NO. 24-021

SUBJECT: ROBERTSON RECREATION CENTER PROJECT – SITE IMPROVEMENTS (PRJ21608) PROJECT – COMMITMENT OF PARK FEES – CATEGORICALLY EXEMPT FROM THE PROVISIONS OF THE CALIFORNIA ENVIRONMENTAL QUALITY ACT (CEQA) PURSUANT TO ARTICLE 19, SECTION 15301 [REPAIR, MAINTENANCE, OR MINOR ALTERATION OF EXISTING PUBLIC STRUCTURES, FACILITIES, MECHANICAL EQUIPMENT, OR TOPOGRAPHICAL FEATURES, INVOLVING NEGLIGIBLE OR NO EXPANSION OF EXISTING OR FORMER USE] OF CALIFORNIA CEQA GUIDELINES AND ARTICLE III, CLASS 1(1) OF CITY CEQA GUIDELINES

Robertson Rec Center

Findings Report Building Envelope Investigation Investigation: August 16, 2022

Fig 03: Detail 9 A9.05 on the Project Drawings by Kevin Daly Architects, dated Feb 2017

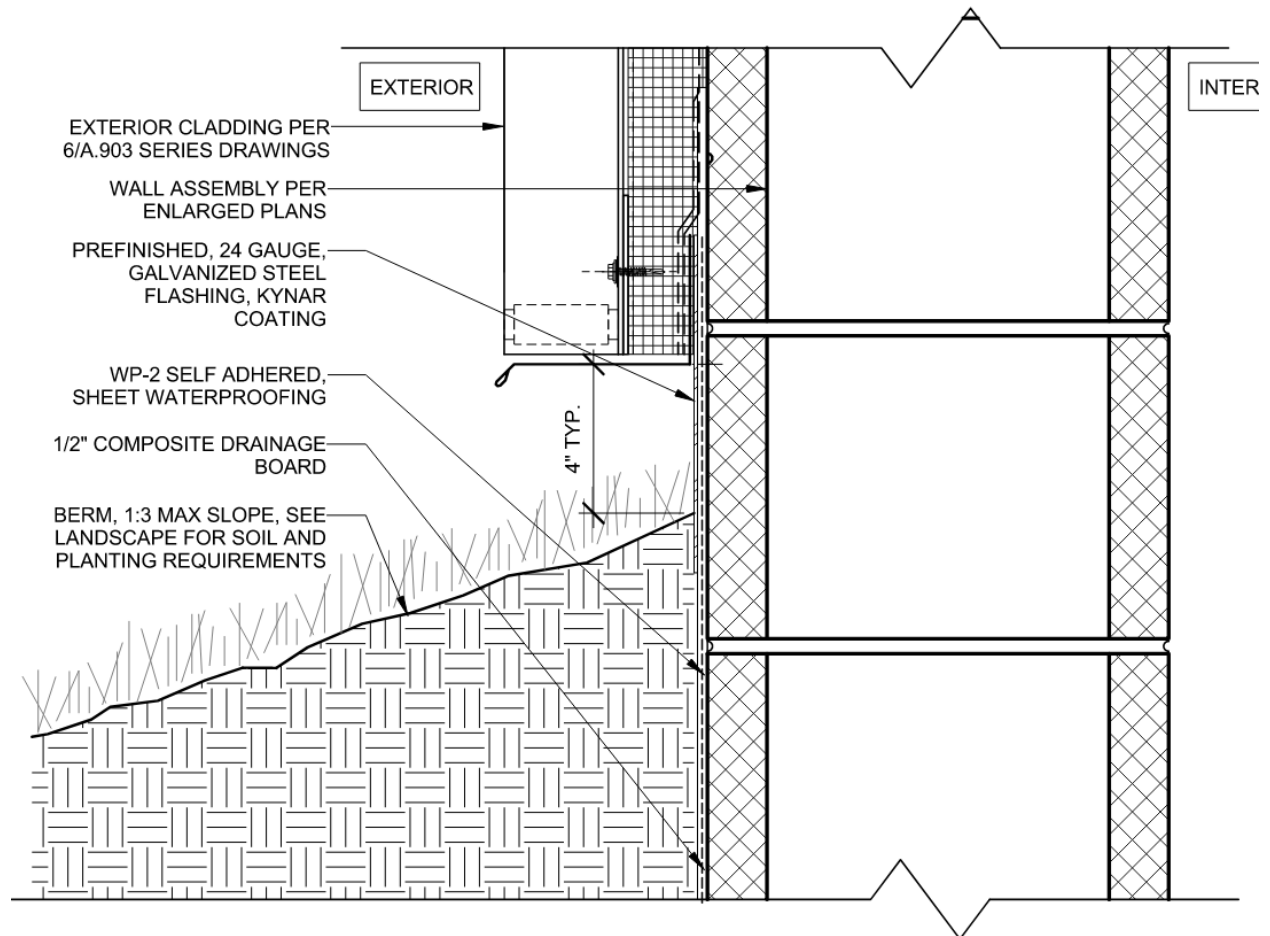
The bottom of the corrugated metal cladding follows the contour of the landscaping along the east and west elevations. In some locations, the drainage mat over the below-grade waterproofing was visible under the termination of the metal cladding. The drain mat appeared to be folded back on itself (**Photos 18 – 20**). Detail 9 A9.05 on the Project Drawings by Kevin Daly Architects, dated February 2017 shows a prefinished 24-gauge galvanized steel flashing with Kynar Coating (figure 03). DTR did not observe this flashing on the west side of the building. Construction photos provided by the BOE appear to show that the flashing may have been omitted on the south elevation where the wall wraps to the west elevation.

If feasible, DTR recommends that flashing be installed at the bottom of the west wall as the project drawings call for (Detail 9 A9.05 see fig. 04). Leaving the drain mat and below-grade waterproofing exposed could shorten the life of the products and create issues as the building ages.

The exposed drain mat on the west side of the building will deteriorate with UV exposure over time, potentially exposing the below-grade waterproofing behind it to damage by UV exposure. Installing the sheet metal flashing called for on Detail 9 A9.05 on the Project Drawings by Kevin Daly Architects, would protect the drain mat and waterproofing systems from UV exposure.

Photo 28:
Perforated aluminum panels appear to have been attached to the window frames and sill track with fasteners (red arrow).
Some of the fastener penetrations leaked during water testing (blue arrow).

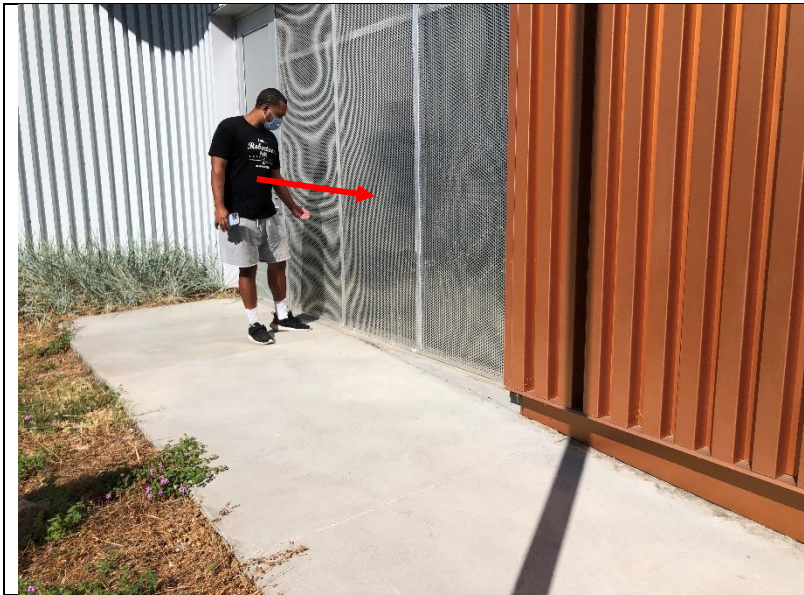
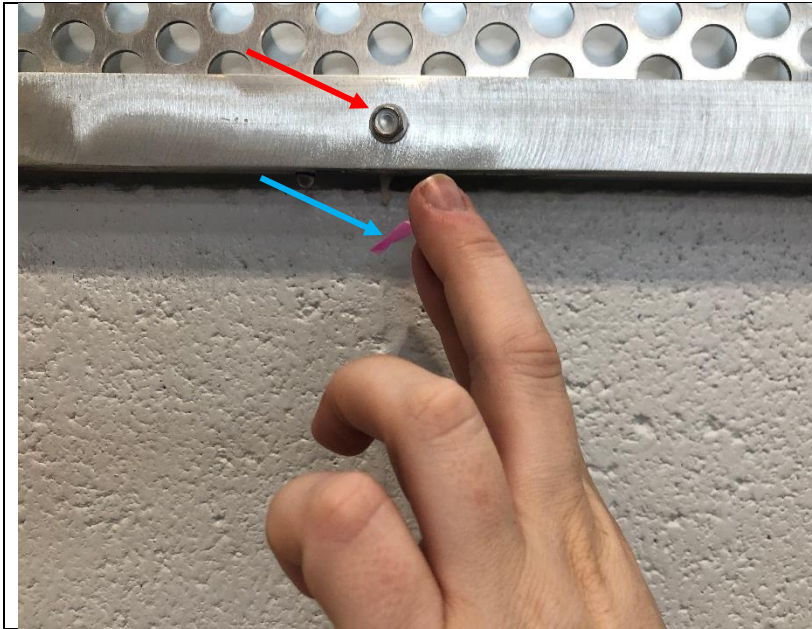
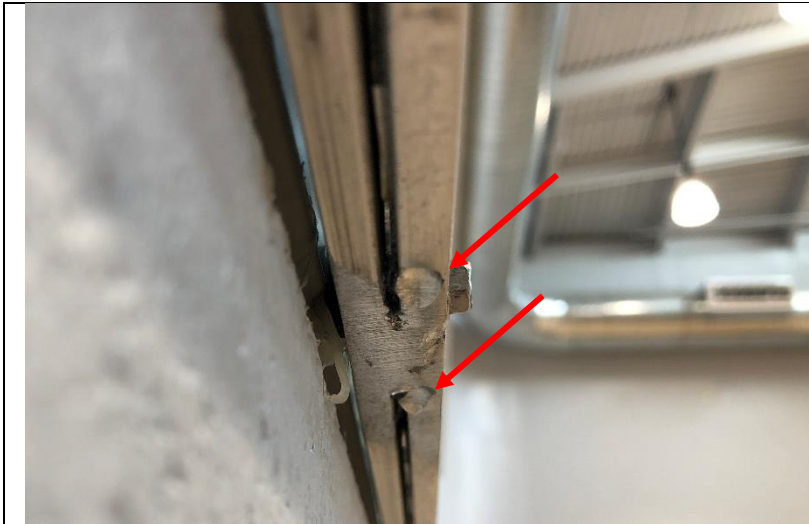
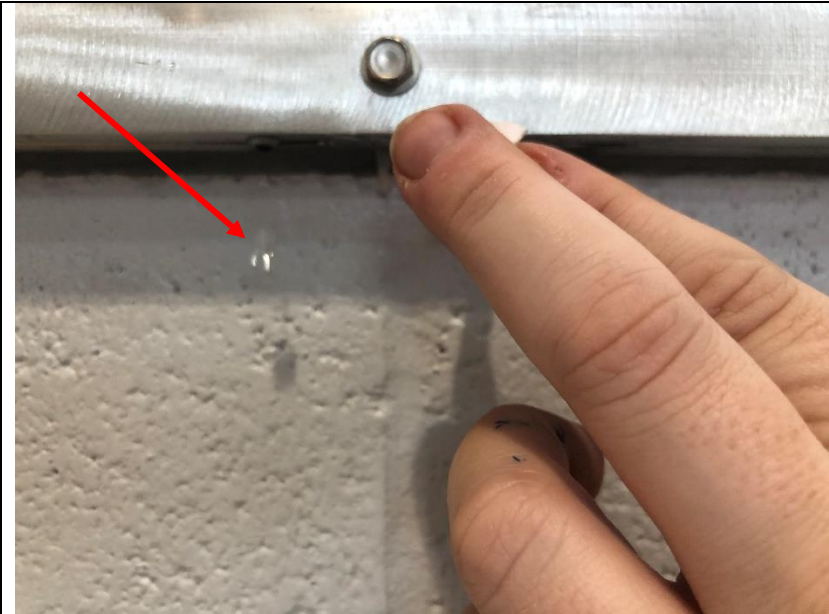
At the windows of the indoor basketball court on the south elevation of the building, the perforated aluminum panels were attached to the interior window frame and sill track with fasteners. In some locations, the fasteners appear to have penetrated the perimeter sealant below the window sill. In other locations, the fasteners penetrate the sill track which is meant to catch water and weep to the exterior (**Photos 27 - 31**). This location correlated with a known leak. The deficiency was verified during water testing (see attached Xpress Testing Field Performance Report for a full description of testing at the Robertson Recreation Center). Below the left window sill (interior) water was observed leaking from a grout joint in the CMU wall (**Photo 32 – 33**).

At the windows on the south elevation of the indoor basketball court, DTR observed that the perforated aluminum panels were attached to the interior window frame and sill track with fasteners. In some locations, what appeared to be clear silicone sealant had been applied at the fastener penetrations along the sill of the window. In other locations, what appeared to be a rubber gasket had been placed on the fastener between the back of the perforated aluminum panels and the window frames. During the water test at this location, several of the fastener penetrations along the bottom of the window leaked. Below the left corner (interior) of the window, water also seeped from a grout joint between the CMU blocks (**Photos 73 – 77**).

Refabricate and reinstall the perforated panels at the window in the basketball court. DTR recommends mounting the modified panels onto the CMU wall and not to the window frame or sill track. The perimeter sealant around the window system should be protected to prevent damage by the mounting of any window protective panel system.

Photo 38:
A window with a missing glazing gasket at the head of the window.

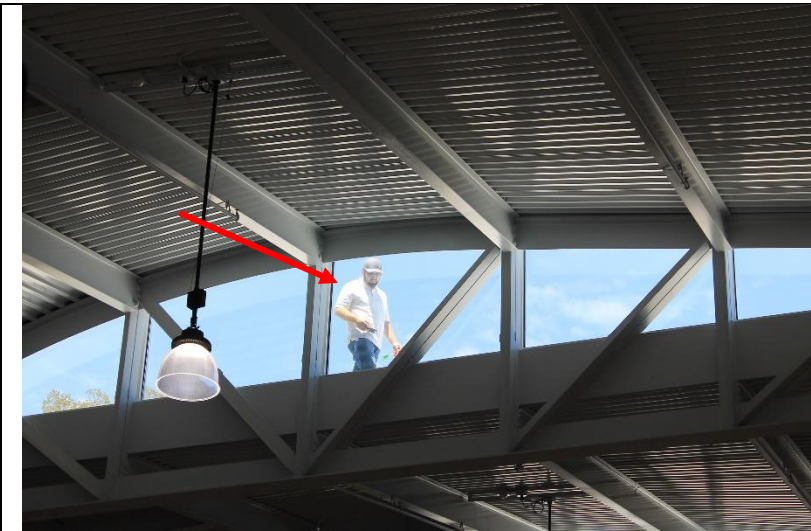
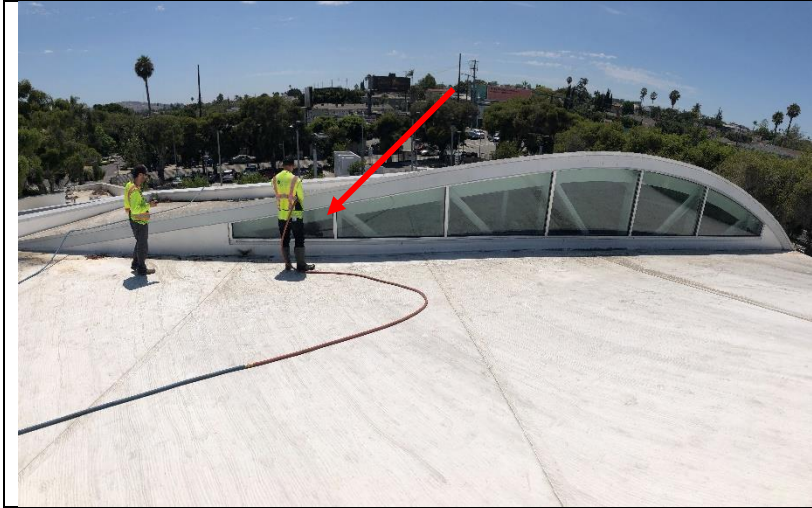
The ribbon windows on the vaulted roof over the indoor basketball court are aluminum framed and have a skirt flashing along the exterior sill of the assembly. The edge-of-roof sheet metal of the vaulted roof is installed over the head of the ribbon windows. DTR noted several loose glazing gaskets at the ribbon windows. A gasket at the head of one glazing unit was missing completely. This location correlated with a known leak. The deficiency was verified during water testing (see attached Xpress Testing report for a full description of water testing at the Robertson Recreation Center) (**Photos 34 - 39**).

Photo 52:
Two kerfs had been cut in the edge of the slab, presumably to promote draining.

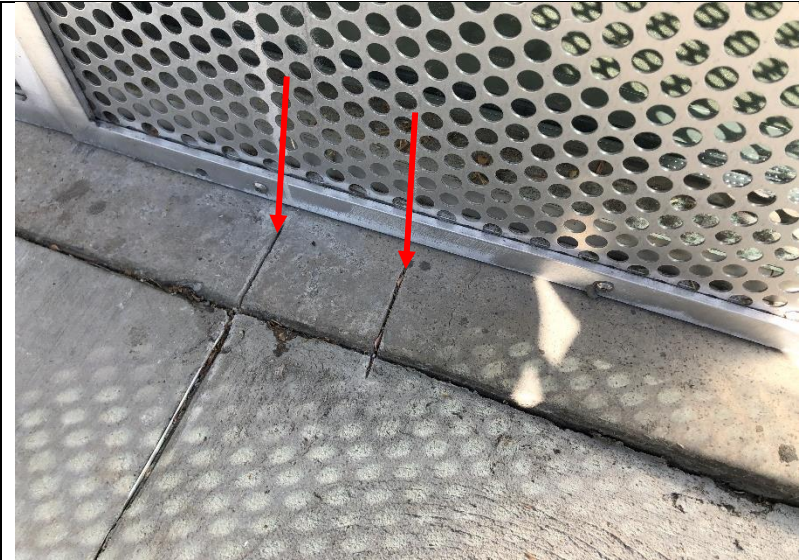
At the storefront and east entry location, the building slab extends past the bottom of the storefront frame and appears to slope back towards the frame. During water testing water pooled on the slab outside the storefront. Two kerfs were cut in the edge of the slab to promote draining (**Photos 51 - 54**).

Photo 55:
The roof hatch on the lower roof.

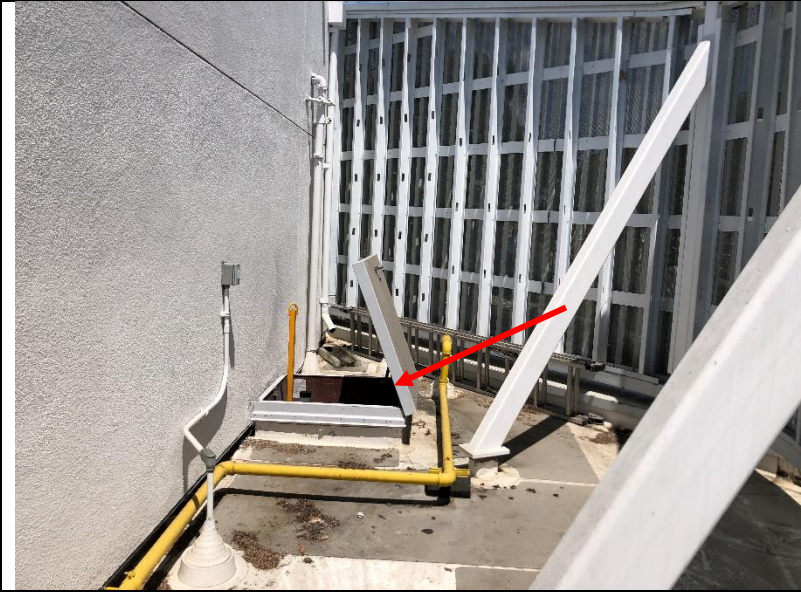
DTR walked the roof and made observations of the systems and materials installed there. The lower roof is accessed by a roof hatch and ladder. As currently constructed, there is no access to the upper roof without the use of a free-standing ladder. The lower roof is congested and does not allow for the easy maneuvering of a free-standing ladder (**Photos 55 - 56**).

Photo 62:
Supper drain and overflow drain at the low parapet adjacent to the steep slope roof on the west side of the building.

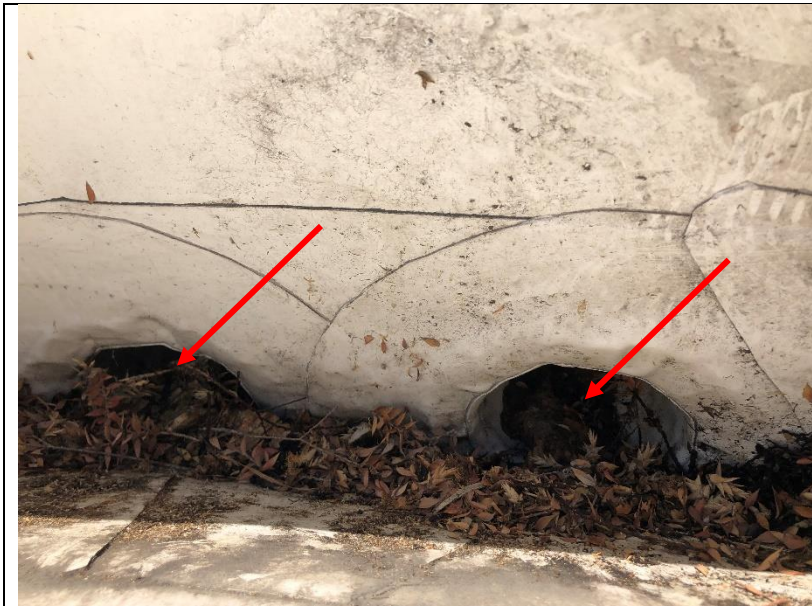
The upper roof over the indoor basketball court is vaulted and has north-facing ribbon windows with aluminum framing. The roof sloped to the east and west. The west side of the upper roof transitioned to a steep slope that terminated at a low parapet. A drain and scupper combination was observed at the low points on the west side of the roof where the parapet meets the roof. Debris and tree matter had blocked both the main and overflow drain at those locations. The east side of the upper roof drains through a drain and scupper combination that flows to the lower roof. Debris and tree matter had partially blocked most of the drain and overflow drains along the east side of the roof. One scupper downspout was blocked by a ball (**Photos 59 - 64**).

The drains on the lower roof were set into a recess. The recess had collected debris from trees adjacent to the building and was not functioning as intended. Some plants had begun to grow in the drain area. The overflow drain appeared to be installed lower than the main drain. The 2-inch flange on the overflow appeared to be at the same height as the main drain flange. As installed, water was not able to flow into the drains as intended. (**Photos 66 - 68**).

Leaf and tree debris have significantly impaired the drains and scuppers from performing as intended. At lower drains on the west side of the building, the slope of the roof creates an area where debris can gather. The slope of the roof is restricting the net free area of the drains and their ability to remove water from the roof surface as intended.
